**Preliminary Plan No. 120110210: Barton Property**

**Preliminary Plan No. 120110210: Barton Property  
(with a Preliminary/Final Water Quality Plan and a  
Preliminary Forest Conservation Plan)**

Request to create one (1) lot from an existing parcel and an existing outlot, located at the south side of Brooke Knolls Road, opposite the intersection with Barton Manor Lane, 2.84 acres, R-200 zone, Upper Rock Creek Area Master Plan

**Staff Recommendation: Approval with condition**

Image 3

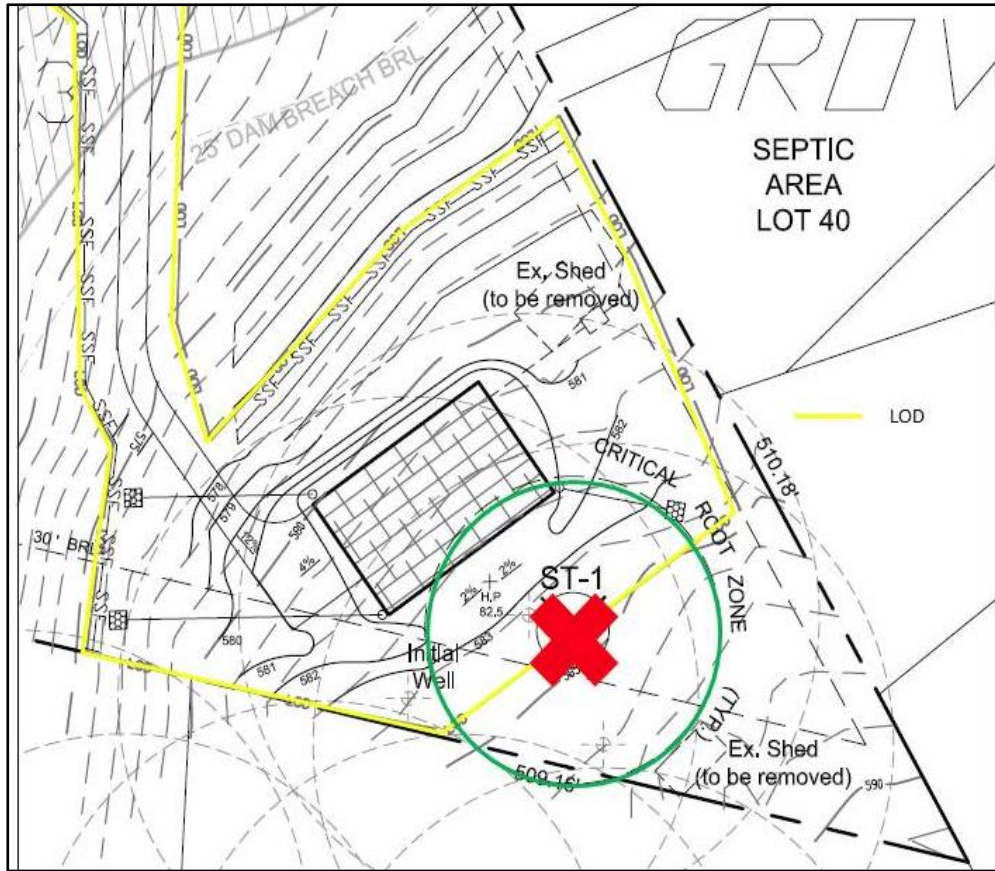
Variance Request - The Applicant submitted a variance request dated May 22, 2012 for the removal of one (1) tree that is 30 inches and greater and considered high priority for retention under Section 22A-12(b) (3) of the County Forest Conservation Law (Attachment H). This tree, a 34-inch DBH black walnut ("Protected Tree") is in moderate condition and is noted as ST-1 on the PFCP, and is located in the southeastern corner of the Property (Image 3).

Mitigation - Staff recommends that mitigation for the loss of the Protected Tree be provided onsite. Mitigation should be at a rate that approximates the form and function of the tree removed. Staff recommends that replacement occur at a ratio of approximately 1-inch caliper for every 4-inch DBH removed. Therefore, mitigation for removal of the 34-inch DBH black walnut must be provided in the form of three (3) native canopy trees with a minimum size of three (3) inches, DBH. While these trees will not be as large as the tree lost, they will provide some immediate canopy.

- ii. Mitigation for the removal of tree ST-1 (34-inch DBH black walnut) in the form of three (3) native canopy trees with a minimum size of three (3) inches in diameter at breast height. The trees must be planted on the Property, outside of any rights-of-way, or utility easements, including stormwater management easements.

PRELIMINARY PLAN  
**BARTON PROPERTY**  
(Parcel 833 & Outlot C; Tax Map GV41)  
Montgomery County, Maryland

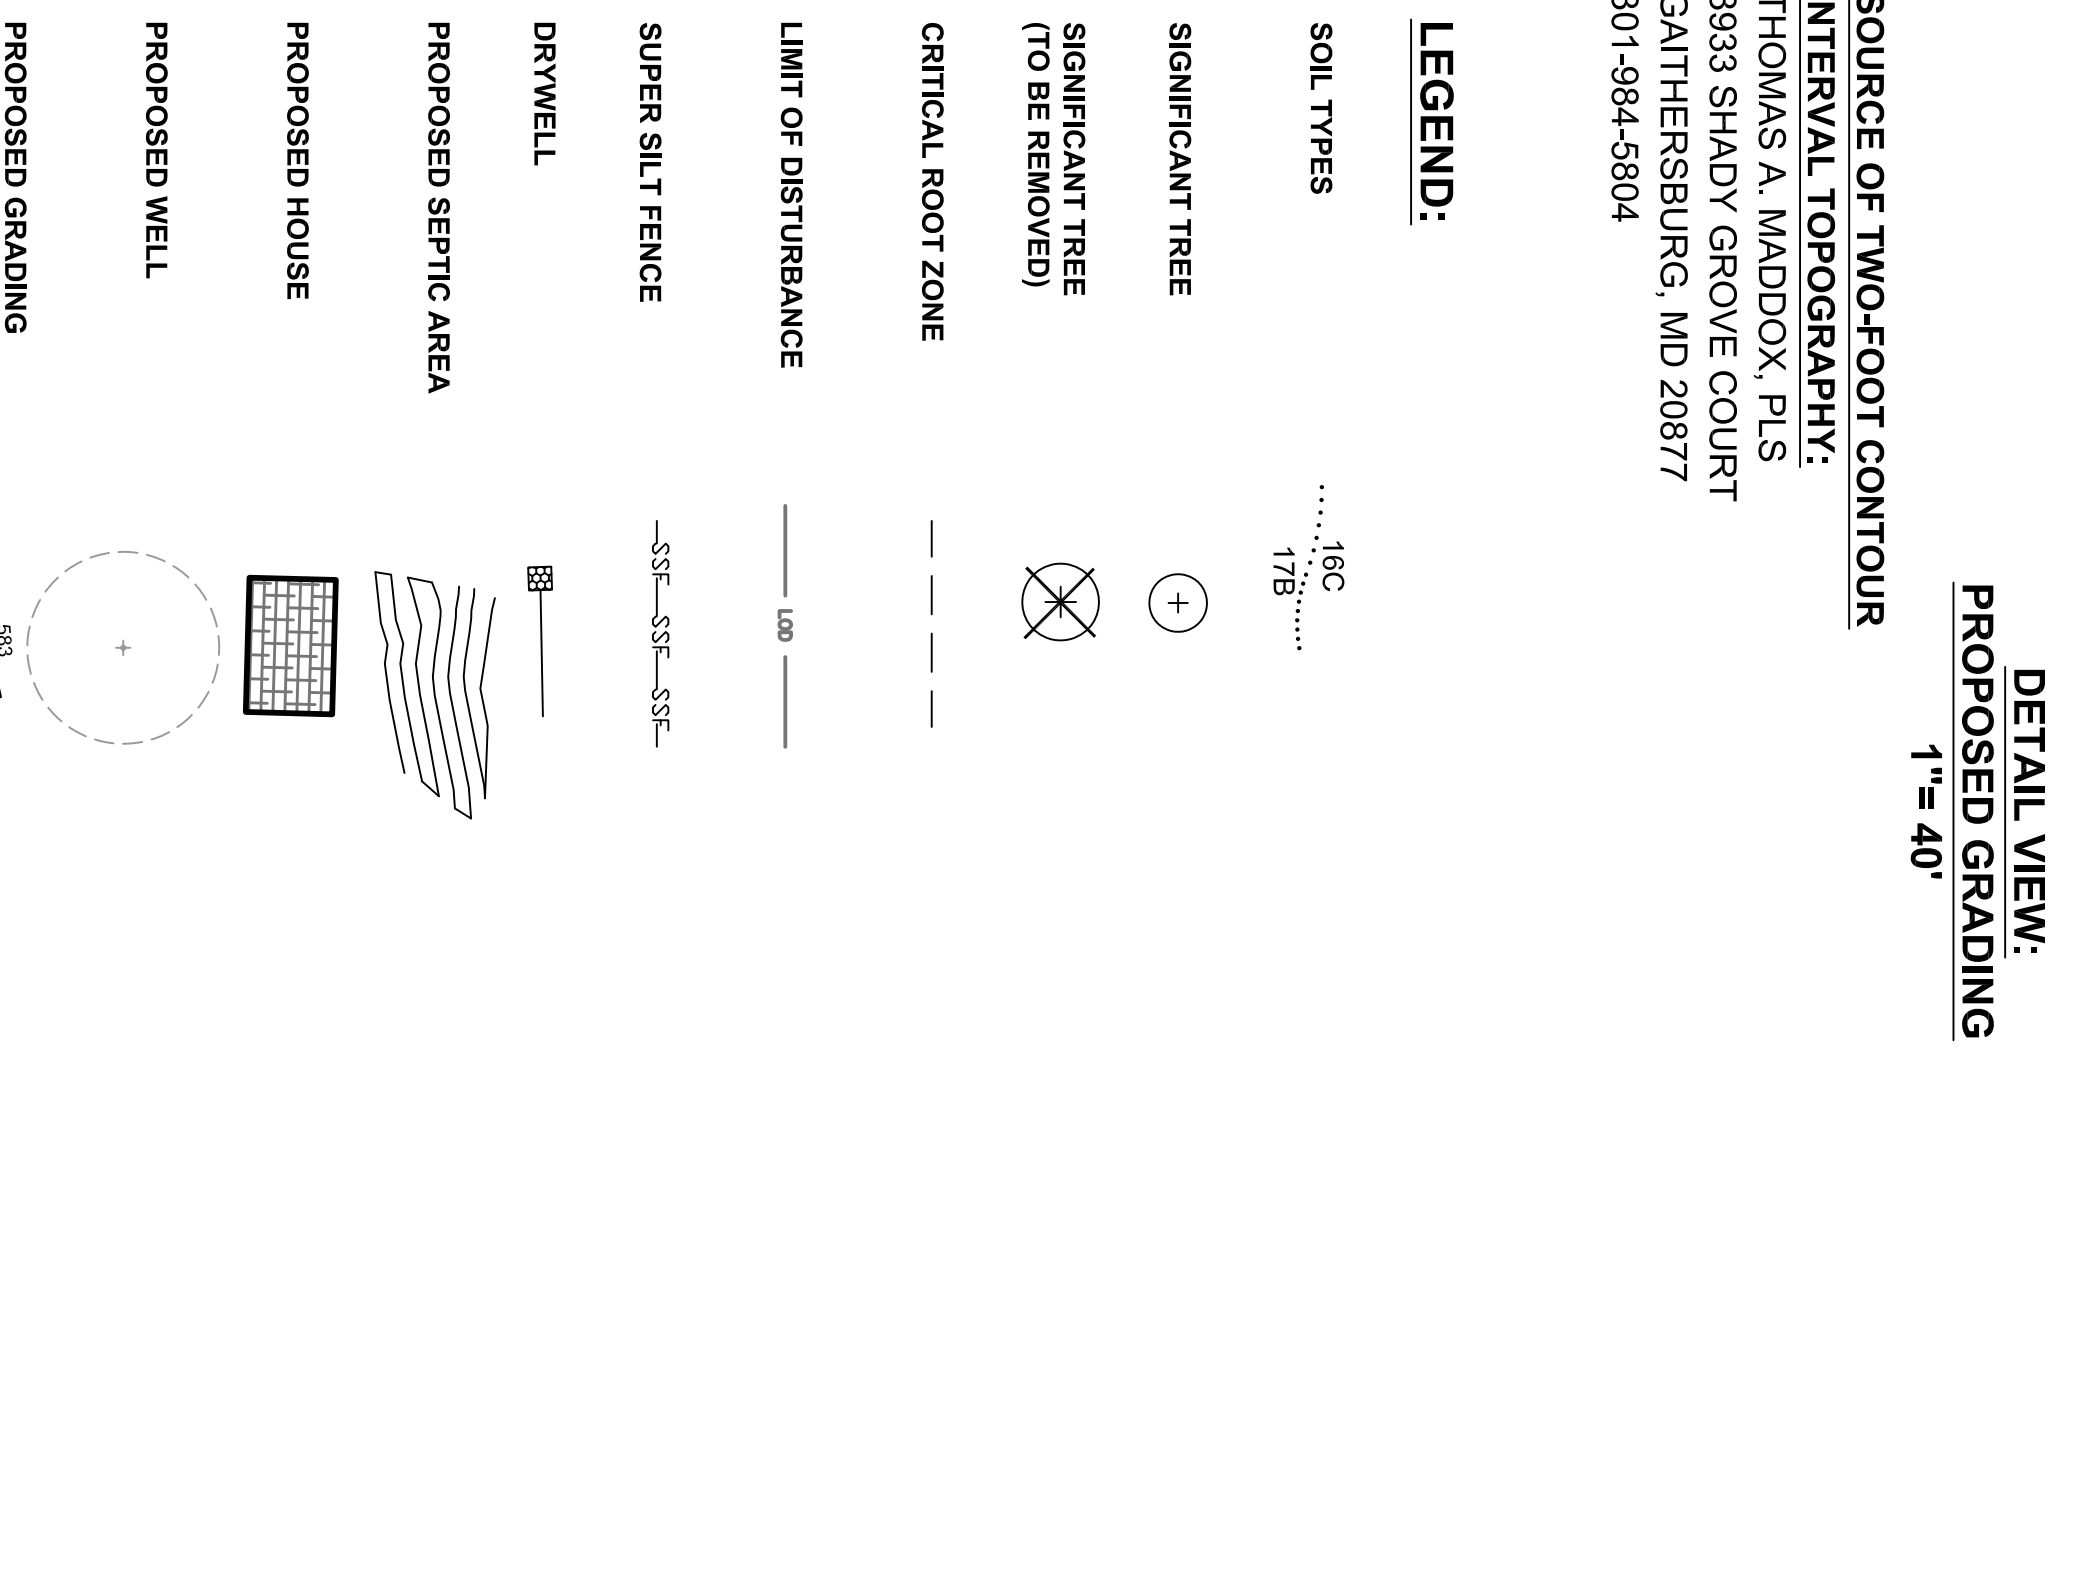
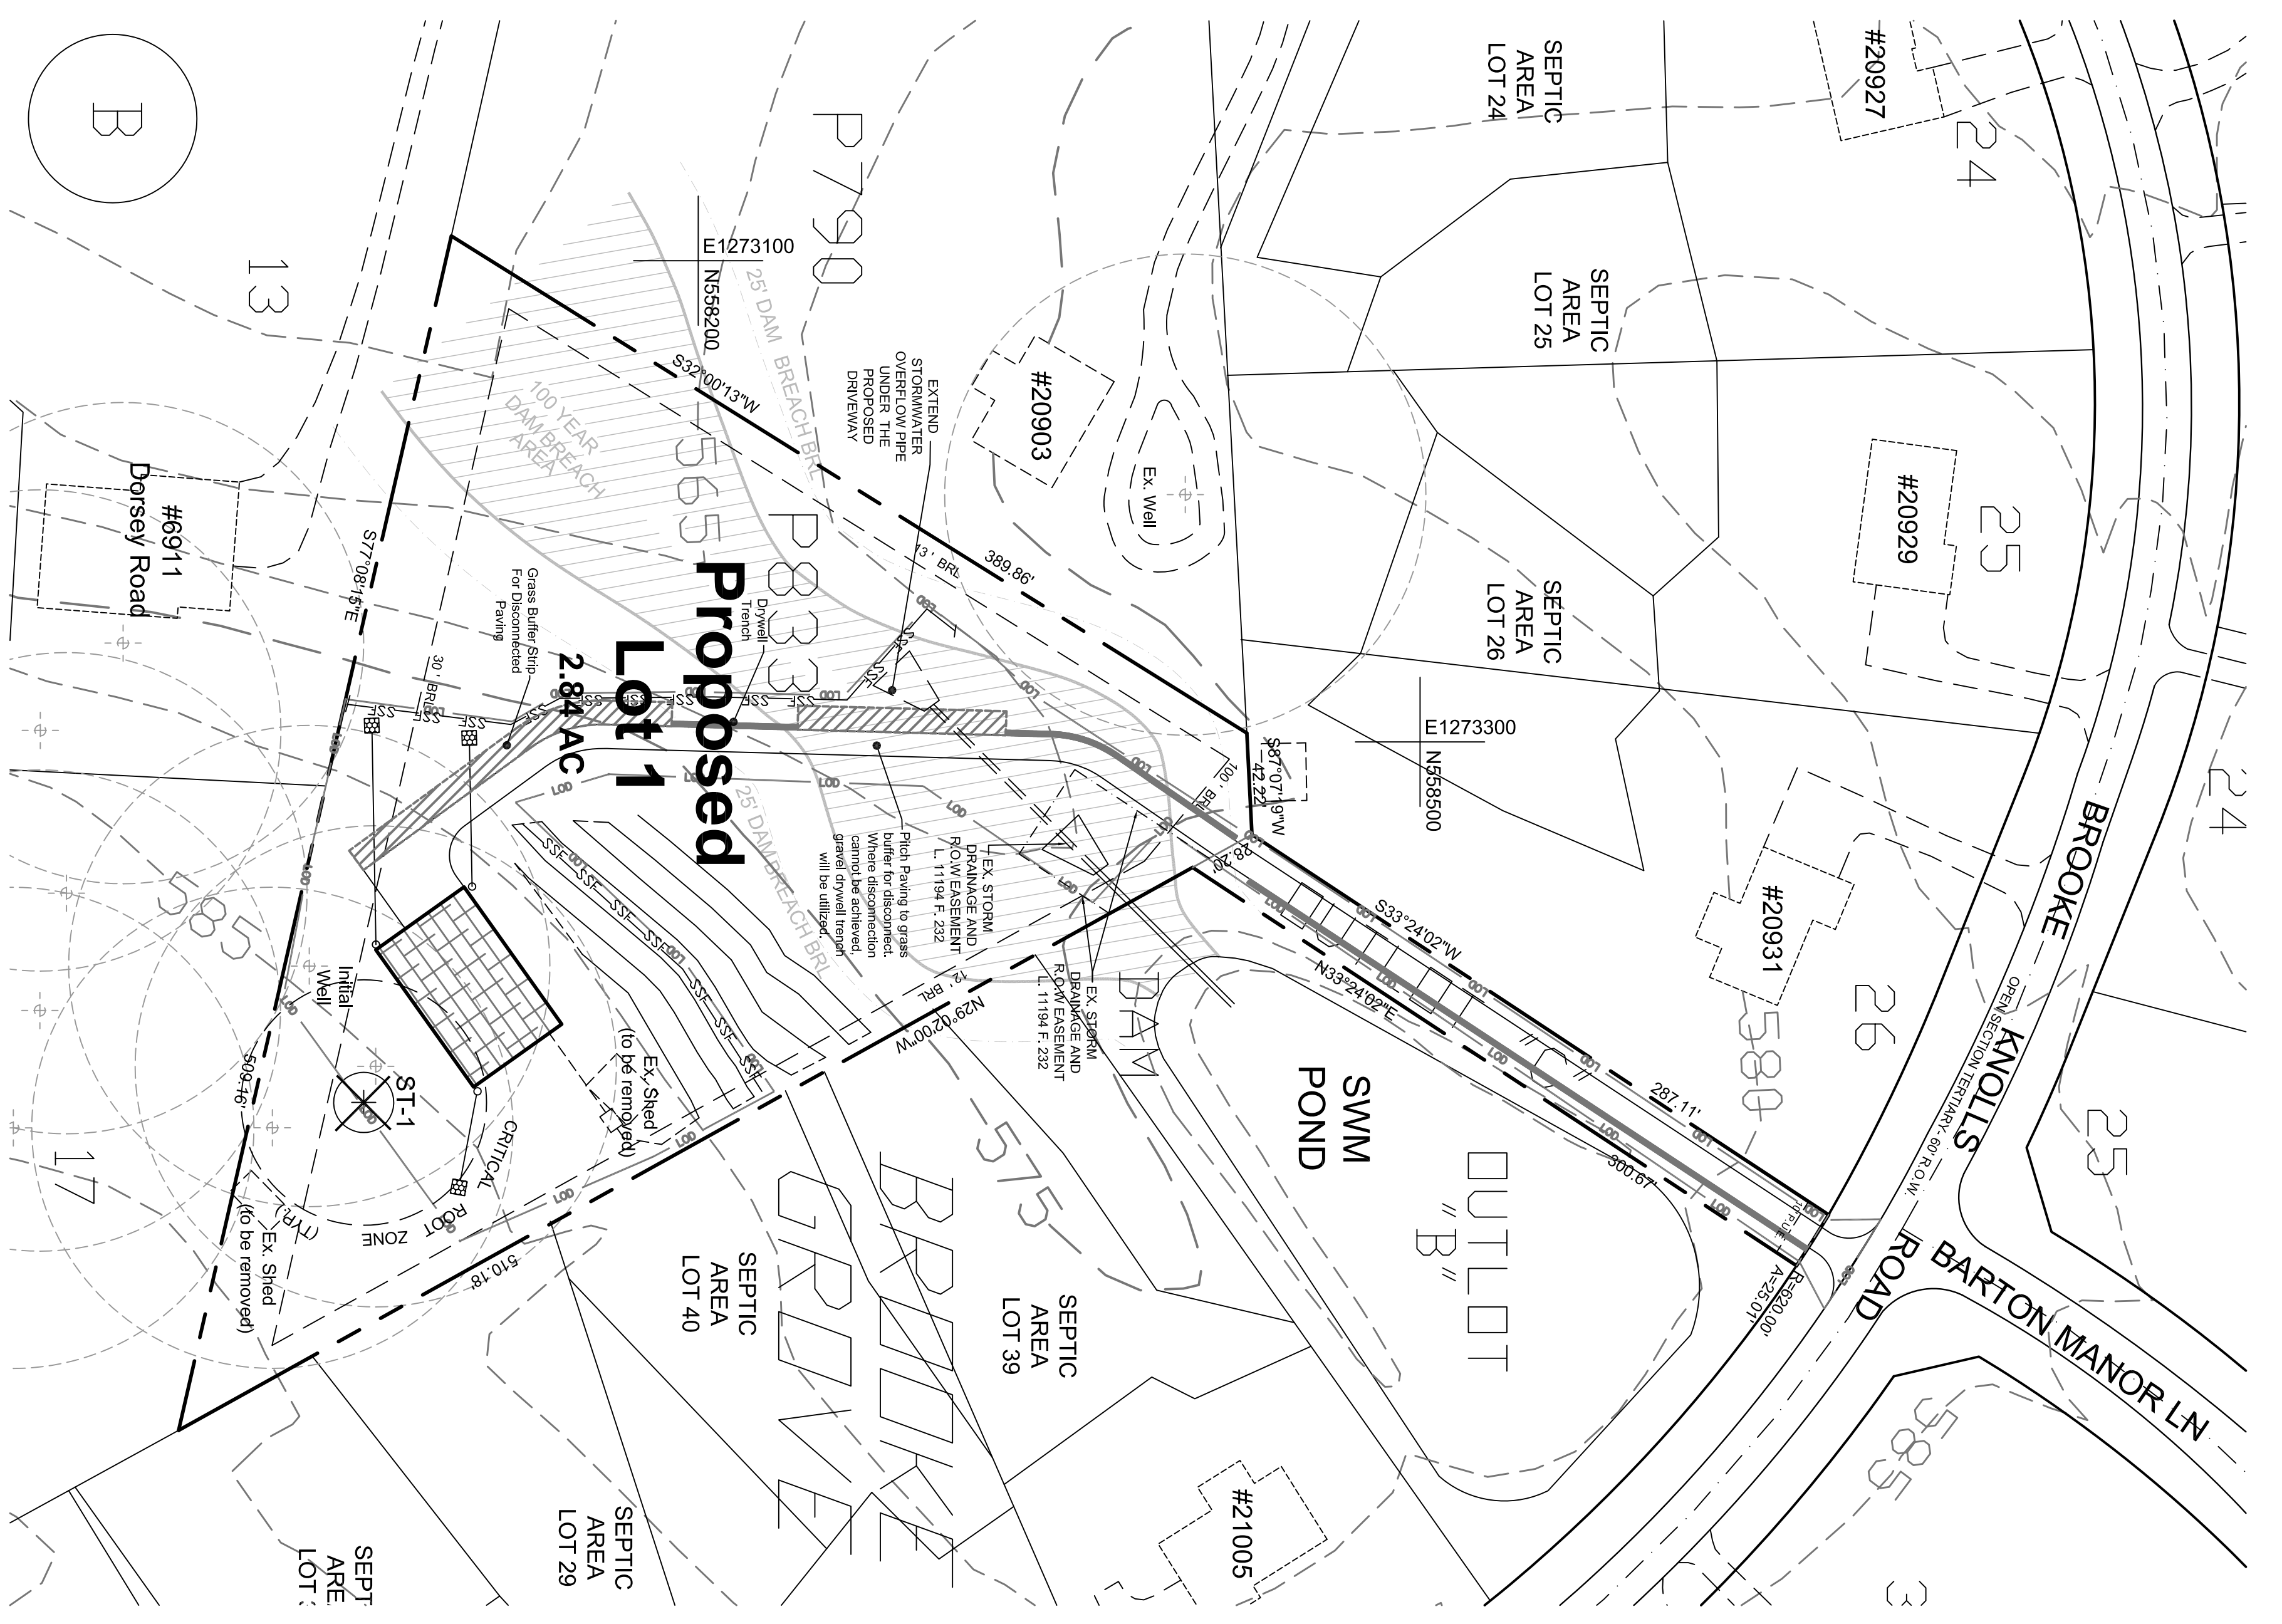
1. The record plat must be at the same scale as the preliminary plan, or submit an enlargement of the plat to match the preliminary plan.
2. The proposed house must utilize an approved septic treatment system with Best Available Technology as approved by the State of MD.

1. Wells and septic systems cannot be located within the right of way nor slope or drainage easements.
2. An amended storm drain capacity study was submitted to our office on June 9, 2013. The amended study indicates the downstream crossing of Dorsey Road (with a 24 inch corrugated metal pipe) is currently clogged and undersized. We have sent a request to flush the existing pipe to clear the blockage. Due to the limited size of this plan with respect to the overall drainage area to that culvert, we will not require this applicant to upgrade that crossing.

PRELIMINARY WATER QUALITY PLAN/  
 FINAL WATER QUALITY PLAN  
**BARTON PROPERTY**  
 (Parcel 833 & Outlot C; Tax Map GV41)  
 Montgomery County, Maryland

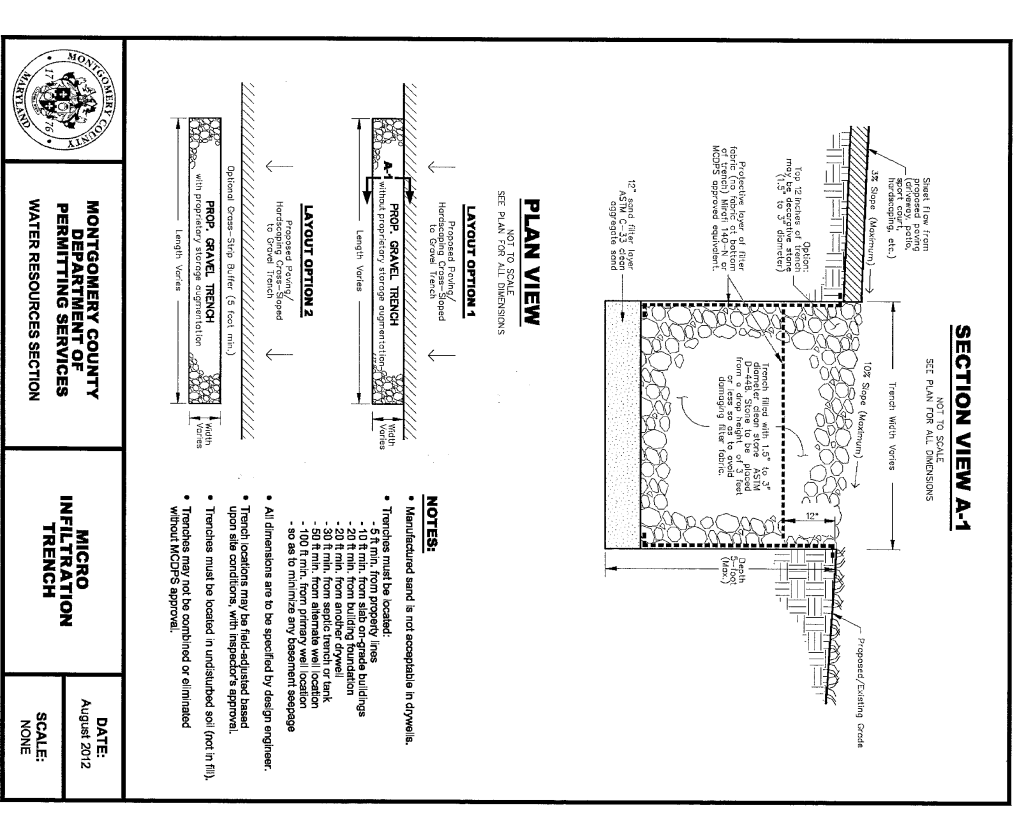
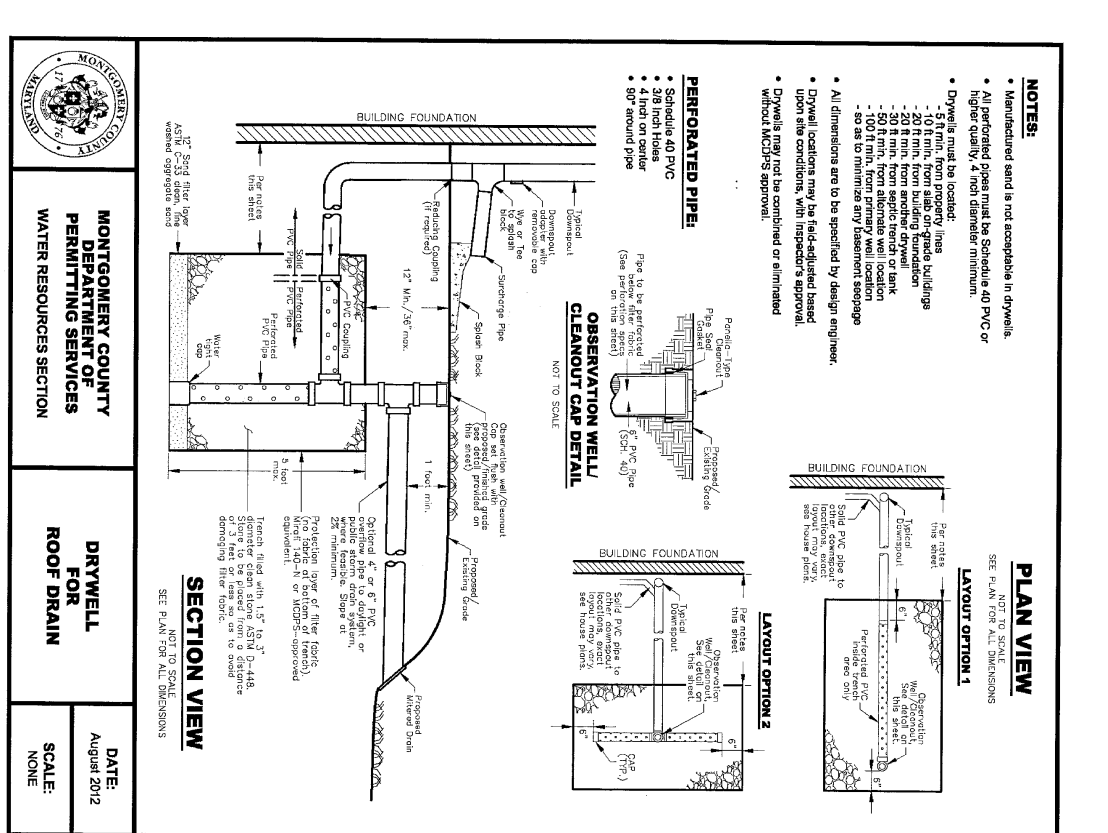
1. It appears that additional gravel trench dry wells will be needed to treat the southern most driveway area where non-rooftop disconnection is proposed due to the steepness of the adjacent slope.
2. A detailed review of the stormwater management computations will occur at the time of detailed plan review.
3. An engineered sediment control plan must be submitted for this development.
4. Prior to permanent vegetative stabilization, all disturbed areas must be topsoiled per the latest Montgomery County Standards and Specifications for Topsoiling.
